ADDENDUM 3

6/4/2025
Capstone at Convington Place
24-064

The Banyan Foundation

1 PARTIAL 1ST FLOOR PLUMBING PLAN - AREA 1
3/32" = 1'-0"

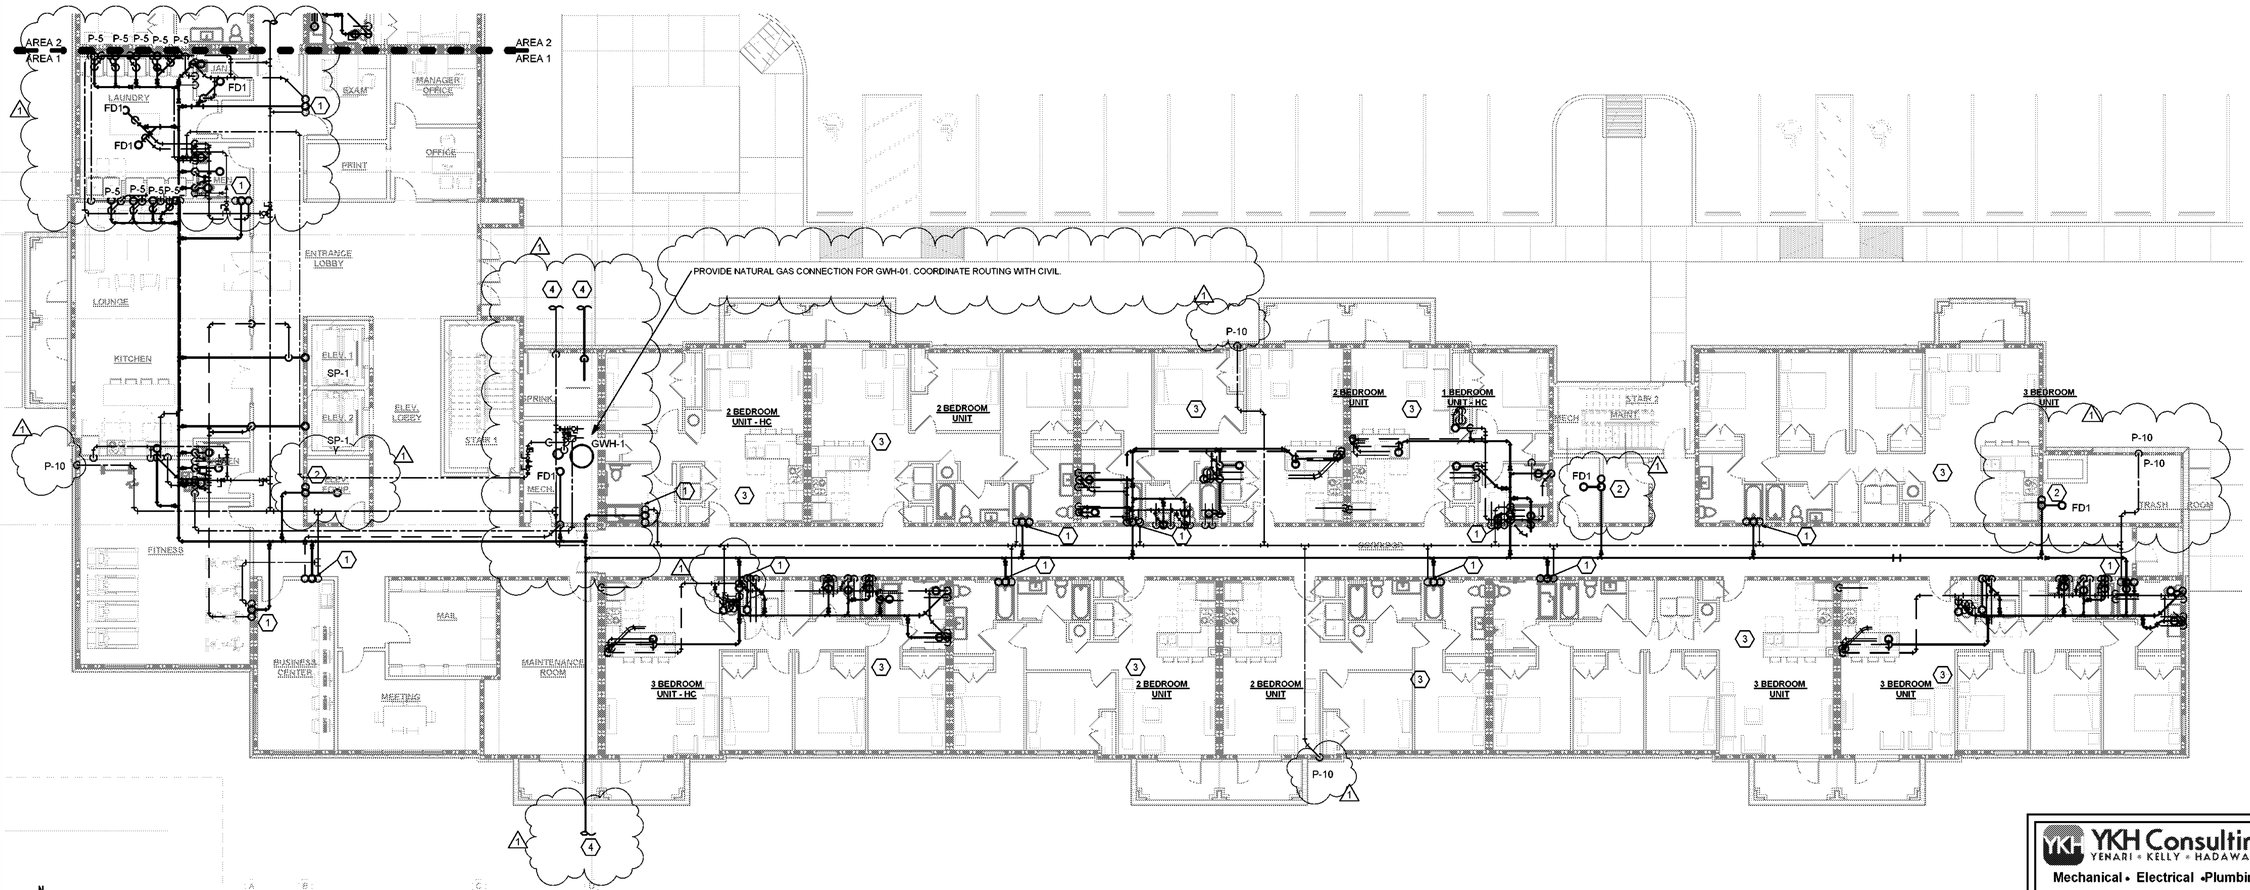
Add 1.100 **P201 – Partial, 1st Floor Plumbing Plan – Area 1**
- Note changes to 1P201.
- Note changes to Specific Notes.

1 PARTIAL 1ST FLOOR PLUMBING PLAN - AREA 2
3/32" = 1'-0"

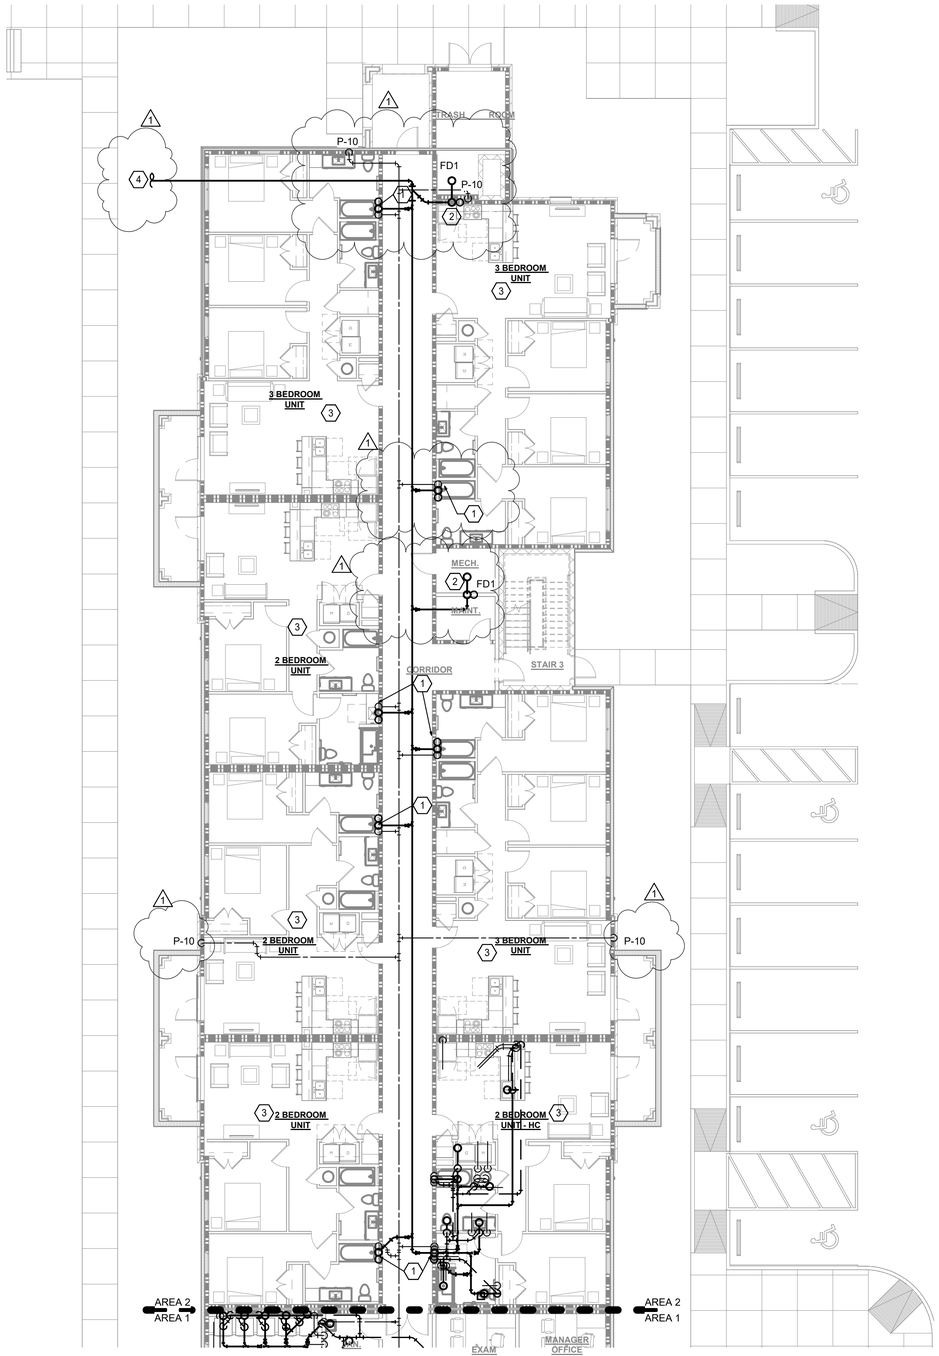
Add 1.101 **P202 – Partial, 1st Floor Plumbing Plan – Area 2**
- Note changes to 1P202.
- Note changes to Specific Notes.

1 PARTIAL 2ND FLOOR PLUMBING PLAN - AREA 1
3/32" = 1'-0"

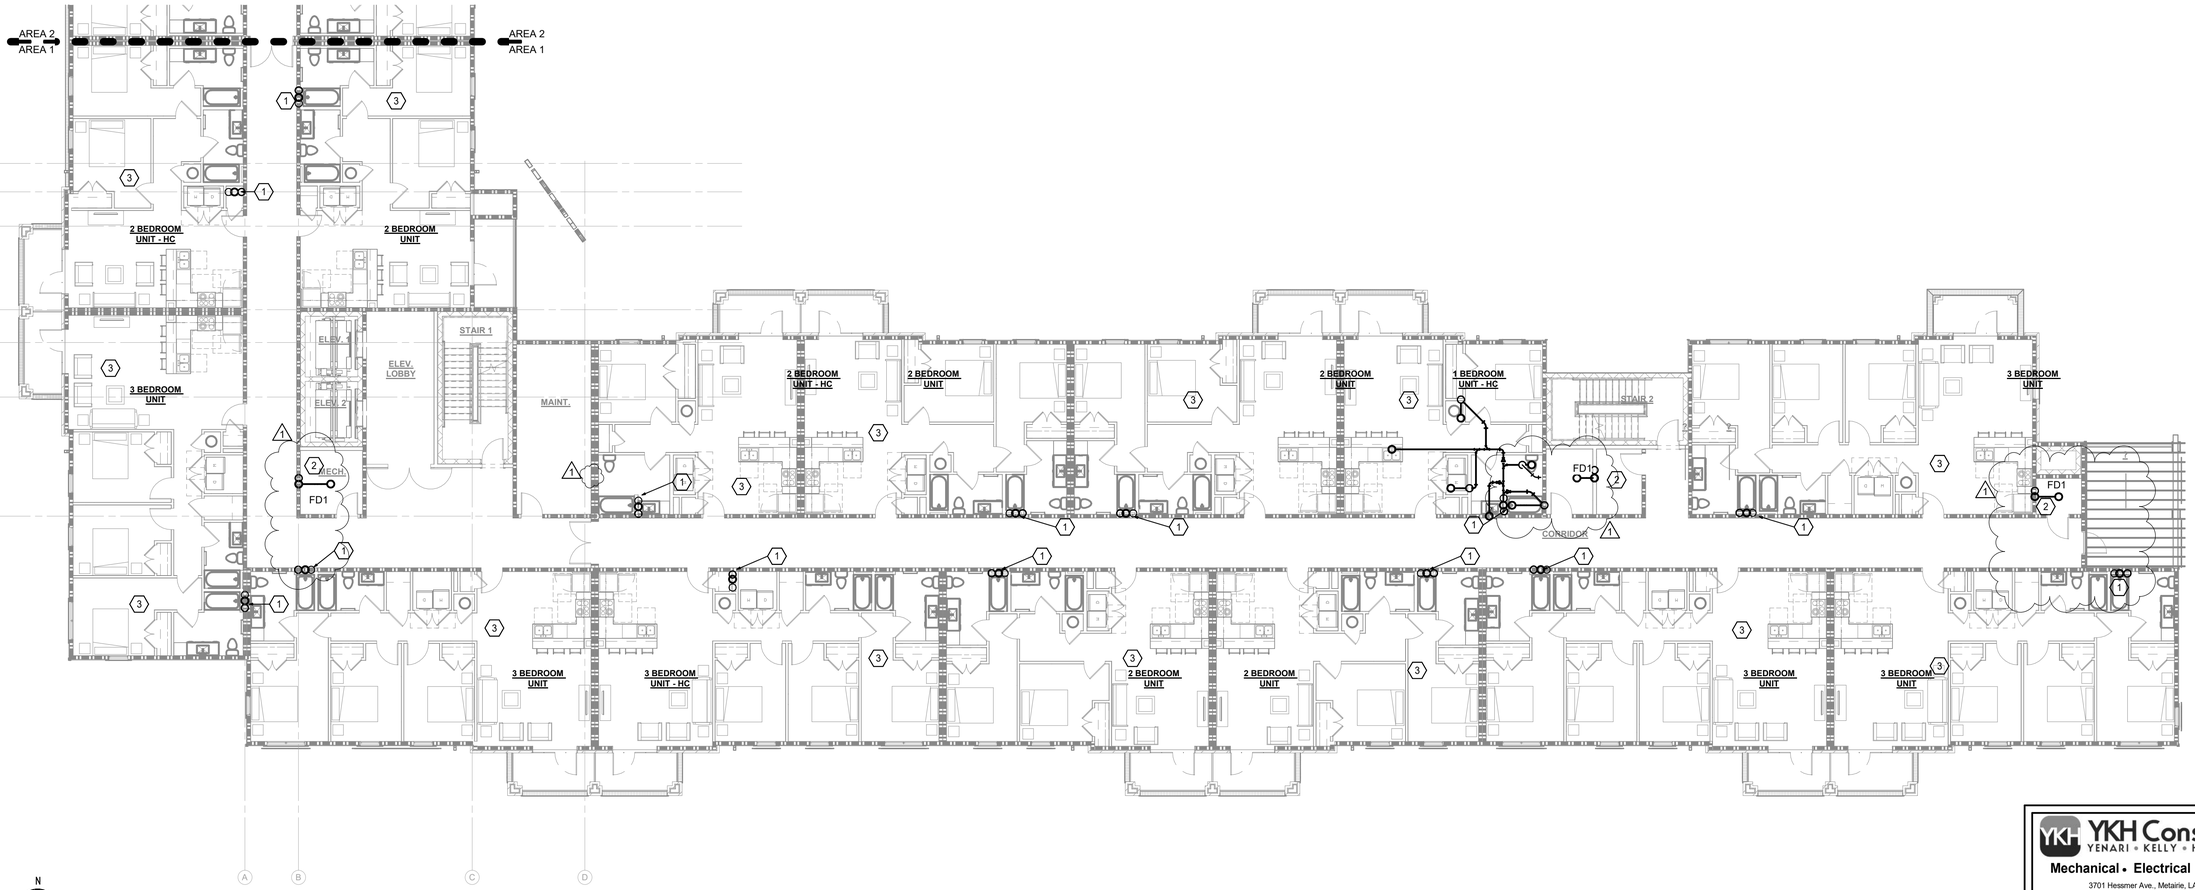
Add 1.103 **P204 – Partial, 2nd Floor Plumbing Plan – Area 1**
- Note changes to 1P204.

1 PARTIAL 4TH FLOOR PLUMBING PLAN - AREA 1
3/32" = 1'-0"

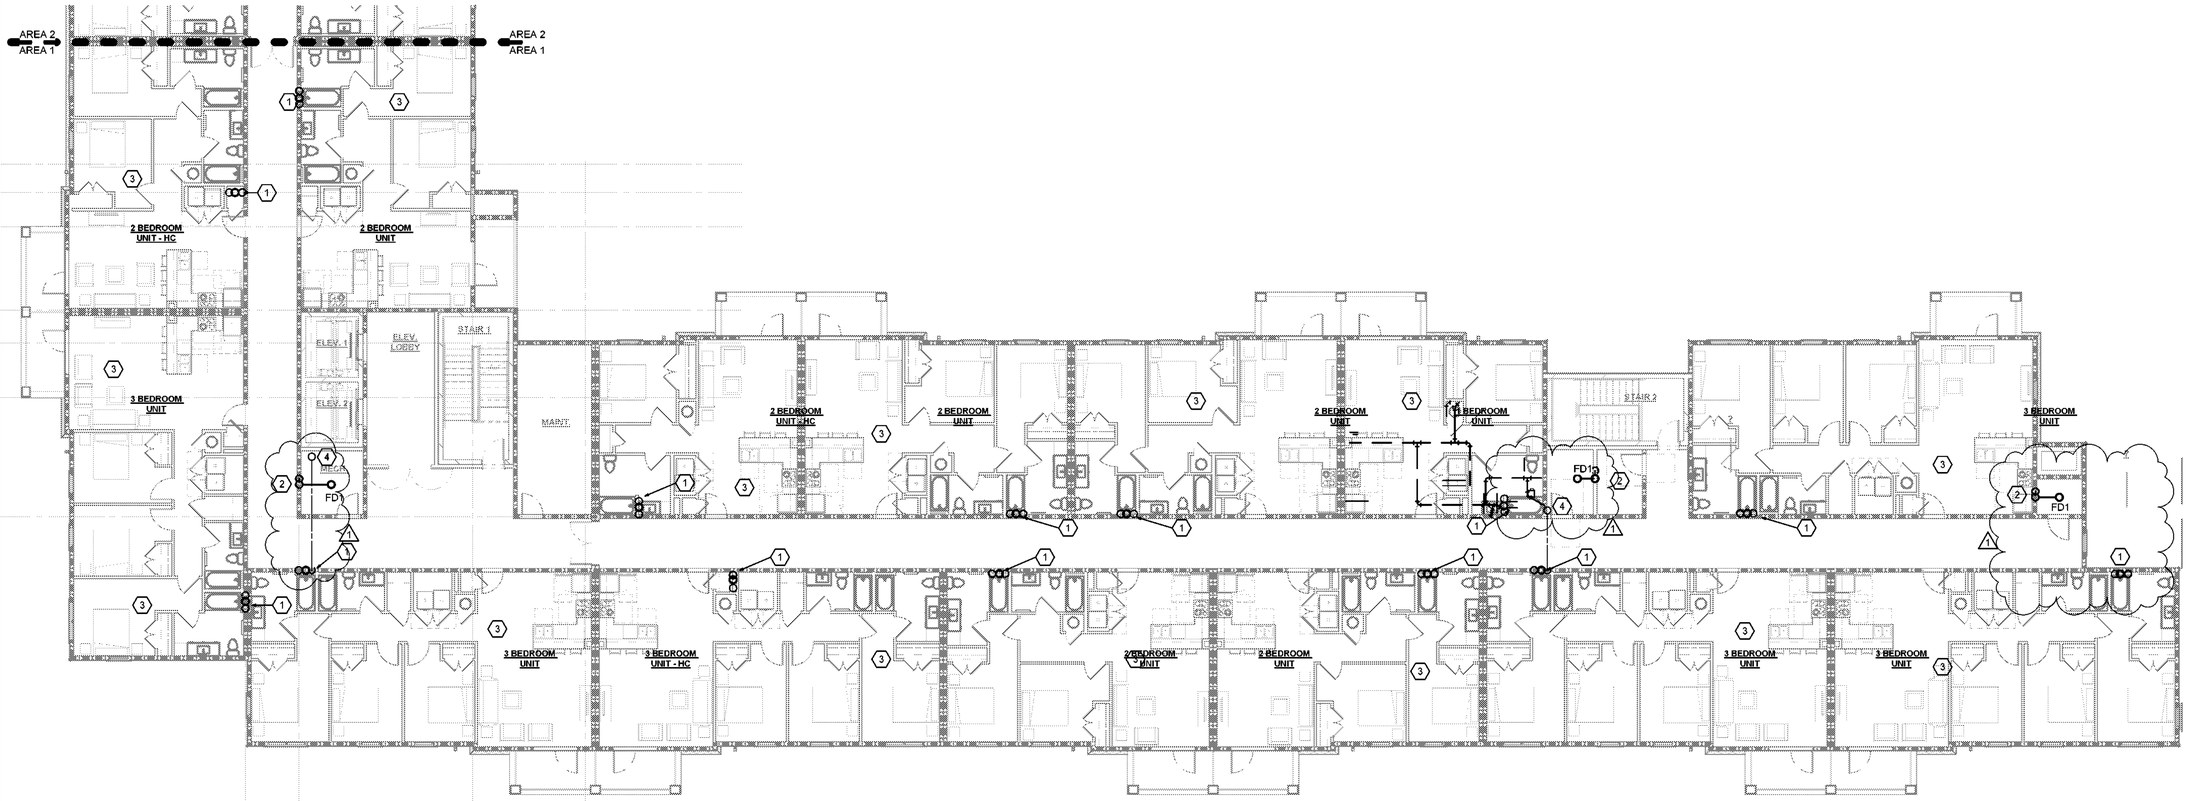
Add 1.4 PC-037: Plumbing: Will there be any roof hydrants required? If so, please provide locations, quantities, and type.

Add 1.109 **P210 – Partial, 4th Floor Plumbing Plan – Area 1**
- Note changes to 1P210.

- **YKH:** Yes, roof hydrants to be located on plumbing plans.

1 PARTIAL 4TH FLOOR PLUMBING PLAN - AREA 2
3/32" = 1'-0"

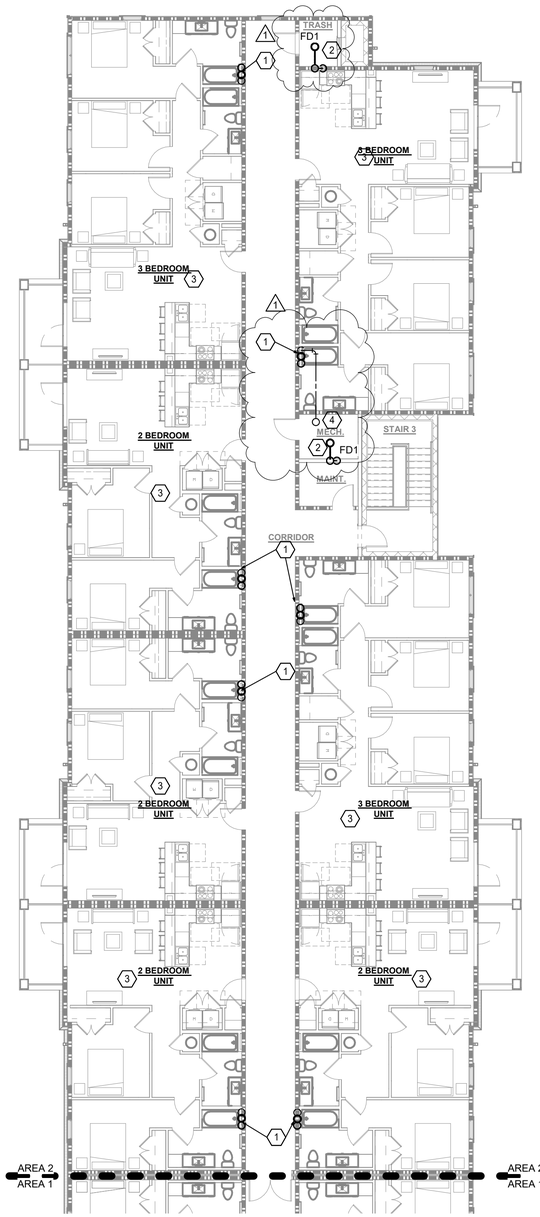
Add 1.110 **P211 – Partial, 4th Floor Plumbing Plan – Area 2**
- Note changes to 1P211.
- Note changes to Specific Notes.

1 ENLARGED PLUMBING PLAN - ACTIVITY CENTER

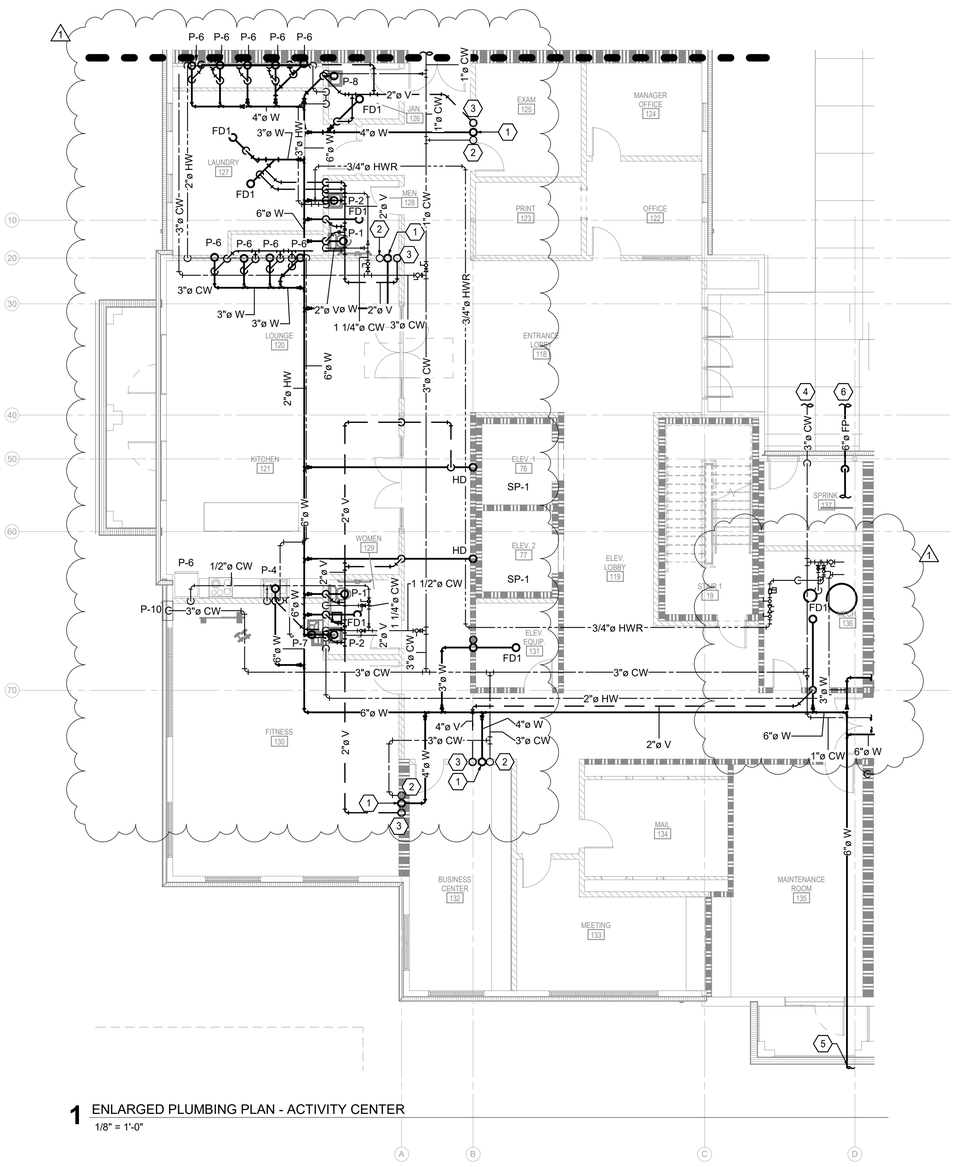
Add 1.3 PC-036: Plumbing: Please confirm there are no floor drains required at activity center laundry room, janitor closets, or trash rooms..

Add 1.118 **P703 – Enlarged Plumbing Plan – Activity Center**
- Note changes to 1P703.

- **YKH**: Floor drains to be added to these locations.

1 FOUNDATION PLAN - 1
3/32" = 1'-0"

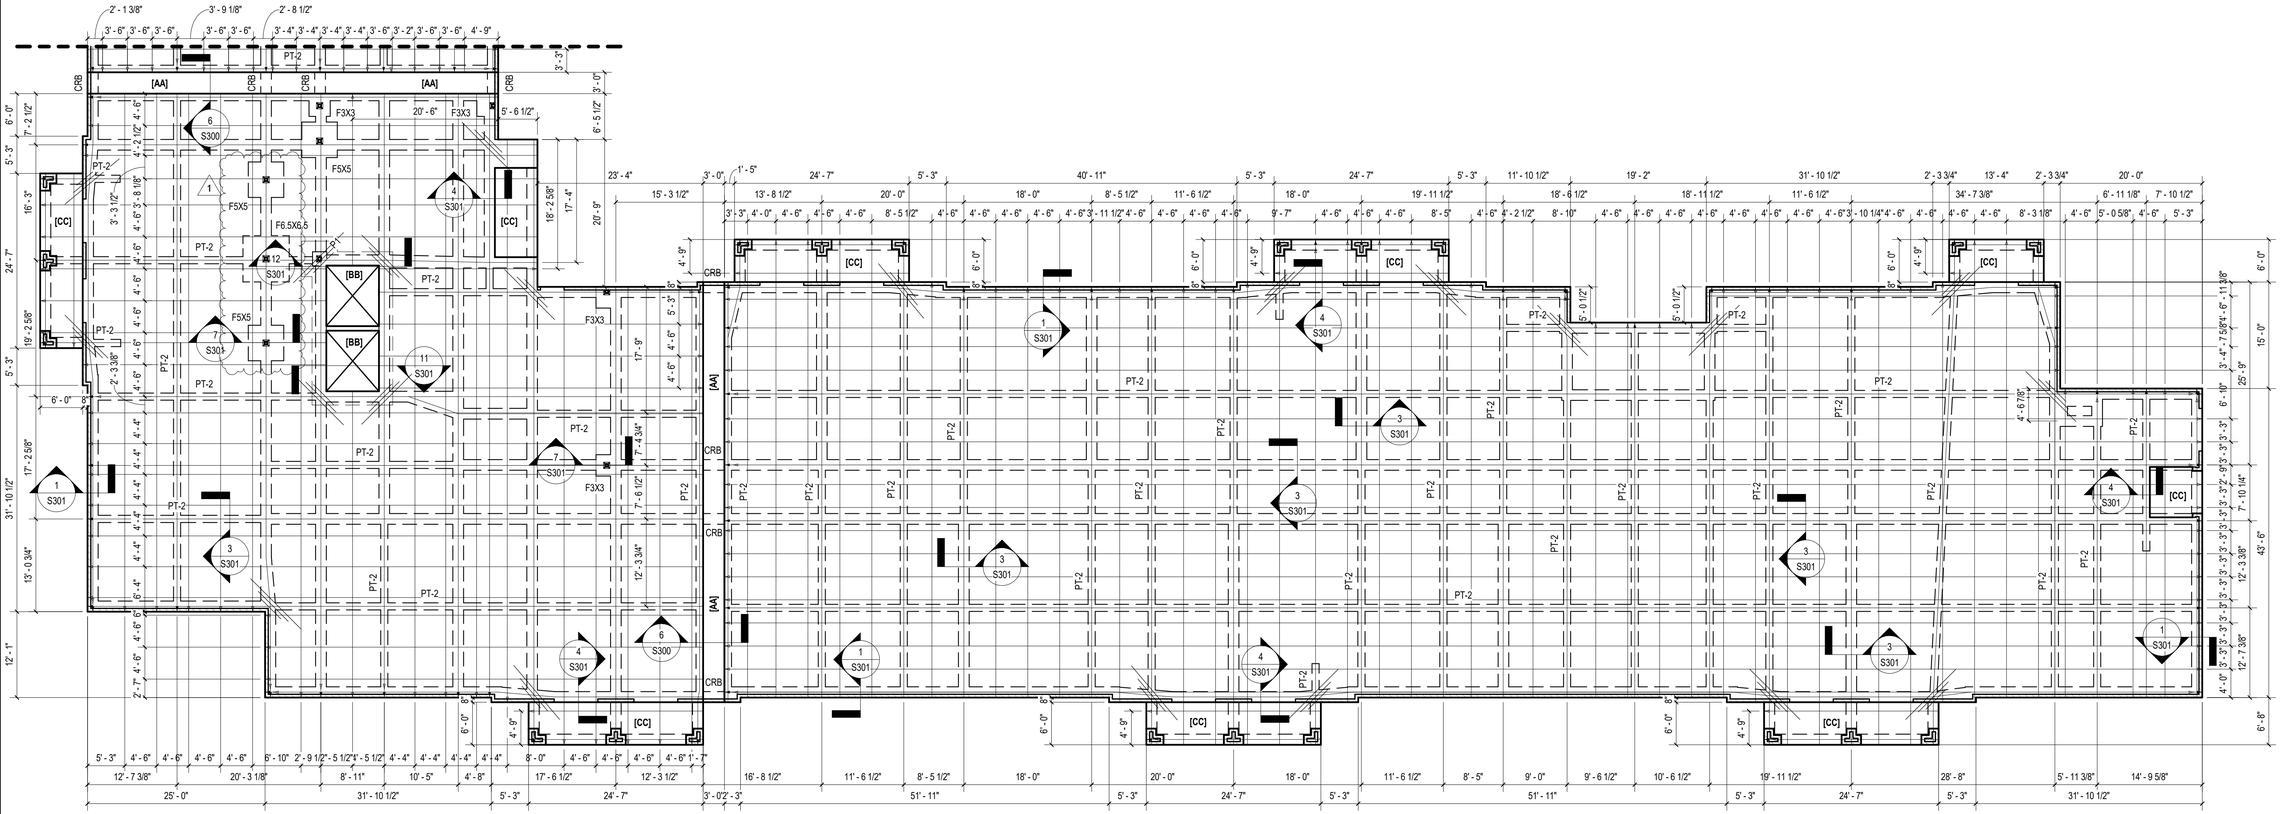
Add 1.24 **S100 – Partial Foundation Plan - 1**
- Note changes to 1S100.
